Groundwater Application Review Summary Form

Application # G- 18521 - rereview

PUBLIC INTEREST REVIEW FOR GROUNDWATER APPLICATIONS

TO: Water Rights Section Date 10/16/2018
 FROM: Groundwater Section Aurora C Bouchier
 SUBJECT: Application G- 18521 Supersedes review of 4/12/2018
 Date of Review(s)

Water-Level Trends in Nearby Wells

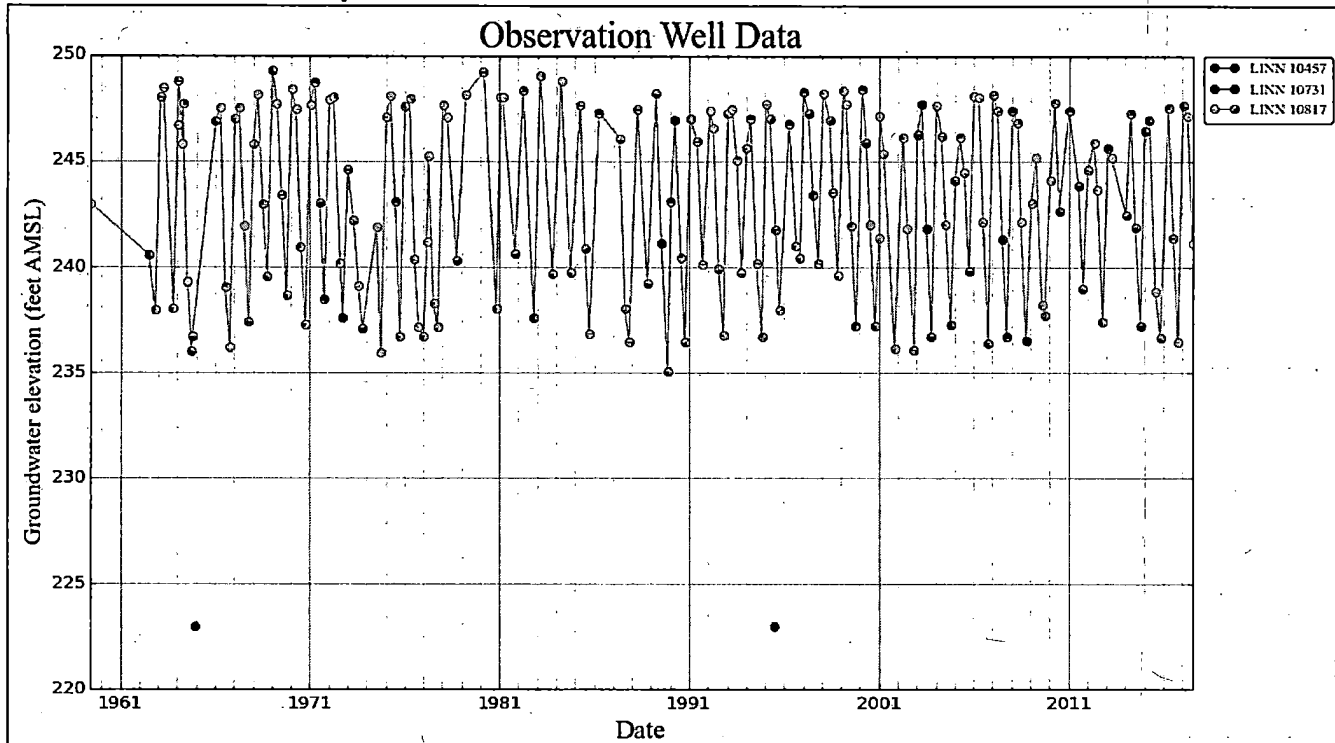
The nearest observation well (LINN 10817, located approximately 4 miles up-gradient to the southeast) has been monitored since the early 1960's. The hydrograph for LINN 10817 shows a seasonal fluctuation of approximately 10-15 feet and no apparent decline, suggesting the aquifer is stable at the current level of use. However, there has recently been a large amount of groundwater applied for in this area.

Stream Depletion Model Results

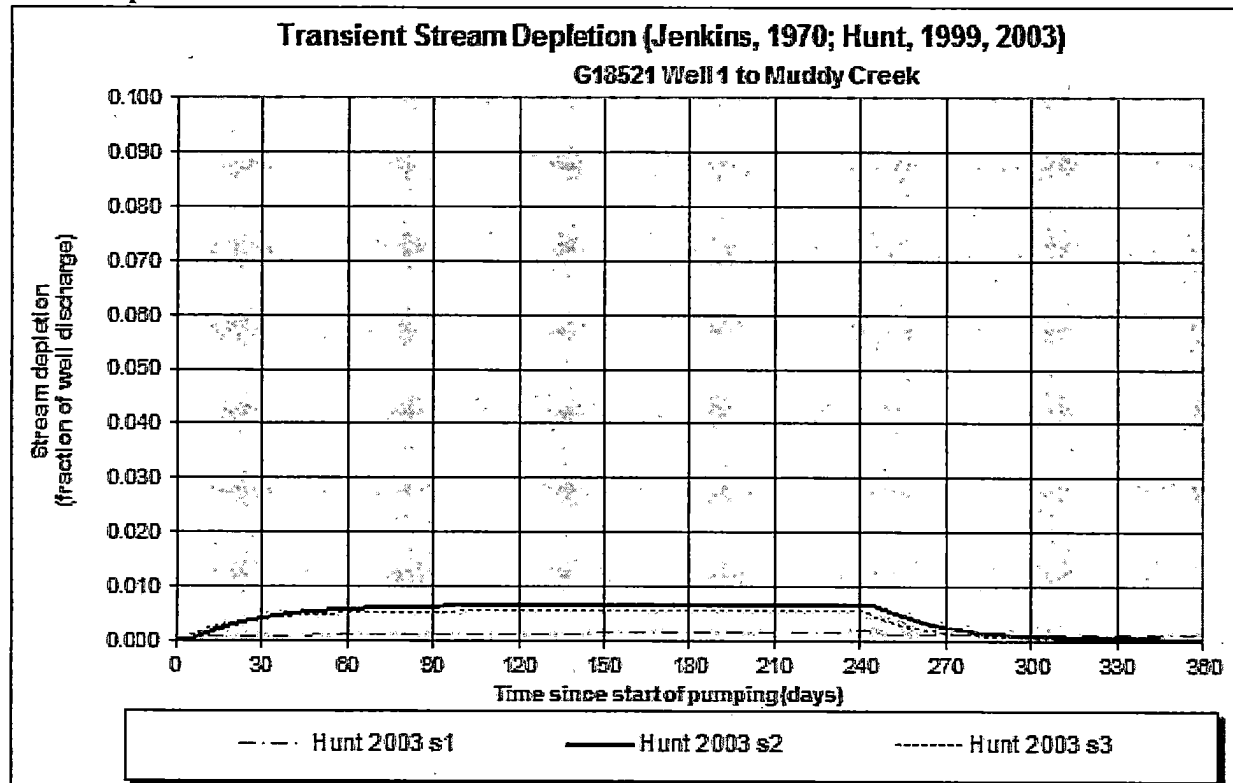
The stream depletion at 30 days was estimated using the Hunt 2003 model. Stream depletion was calculated using the ranges of S, Kv of the streambed, Kh of the Lower Sedimentary Unit as described in Conlon et al. (2005). Only the impact from pumping at the location of Well 1 on Muddy Creek (Watershed ID: 30200303) was modeled. The greater distance between Well 2 and Muddy Creek will act to further reduce the impact to the streams at 30 days. The impact from pumping to the perennial reach of Owl Creek (Watershed ID: 30200321) was not modeled due to the greater distance and significantly larger natural stream flow.
